## Magbee Contractors Supply 2007 Code Update seminar Questions

**FIGURE R502.2.2.1**  
**PLACEMENT OF BOLTS IN DECK LEDGERS (BANDS)**

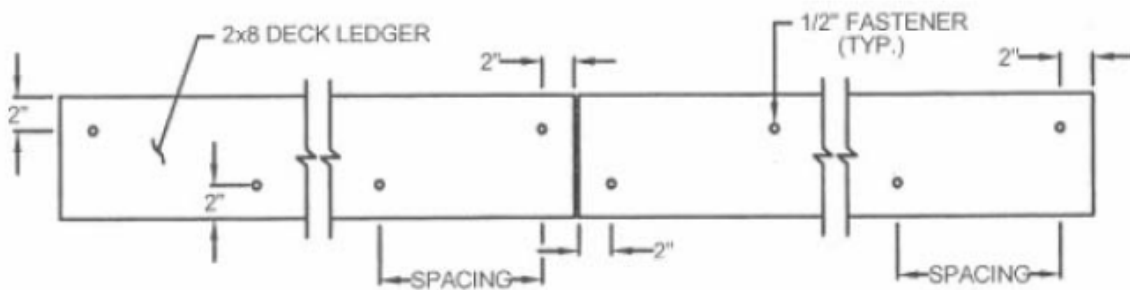
**5 Q. 502.2.2.1 Spacing of bolts on deck attachment.**

**A. Spacing and diagram is in the GA Amendments Table 502.2.2.1 and Figure 502.2.2.1**

FIGURE R602.10.6.2  
ALTERNATE BRACED WALL PANEL ADJACENT TO A DOOR OR WINDOW OPENING

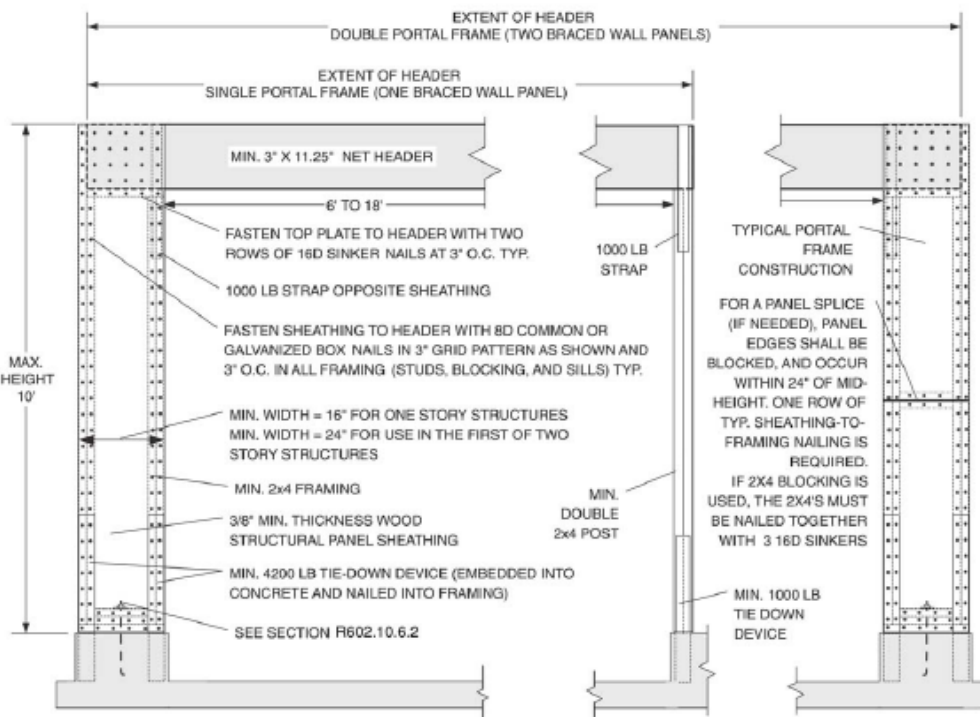
6 Q. Headers over a garage door, do they have to extend all the way to the exterior wall/corner.

A. A complex issues, that has to consider the stories above the garage, if the space above the garage can be habitable, the live load and dead load and the width of the garage door. The maximum height from the ground is 10 feet. The header has to be a minimum of 3" x 11.25". If the garage is on a corner of the house, then the header has to extend to the outside wall or be connected to the wall in an approved manner. The garage door wall normally will be sheathed with a structural panel (plywood/OSB) 16" – 24" past the door and above the door. If there is one or more stories above the garage the 24" space should have studs 12" OC and may have to be blocked horizontally every 24". If the garage doors are 10' or less in width, it is possible to engineer separate headers for each door as long as the headers extend 6" past the door opening and there is 2 or 3 studs (probably 2x6's). This is a Code interpretation issue and one to be discussed prior to doing any framing.
